Proposal #28: 6934-06-73, WISC 2026235
V Biron, CTH U
Biron Drive South to Huffman Road
CTH U
Wood County

This is Addendum No. 02, which provides for the following:

ADDENDUM NO. 02

6934-06-73

SANITARY SEWER, WATER MAIN & UTILITY
TRENCH EXCAVATION & BACKFILL REQMTS.
NOT TO SCALE

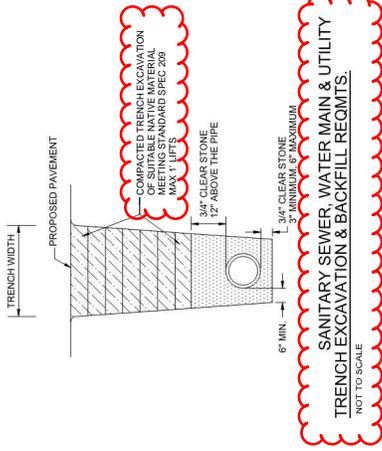
Revised Plan Sheets	
Plan Sheet	Plan Sheet Title (brief description of changes to sheet)
80	Remove "storm" from trench excavation and backfill detail title. Revised backfill note on trench excavation detail to state native material must meet standard spec 209.
174	Added 209.2100 Backfill Granular Grade 2 for use if native material is not suitable for backfill.
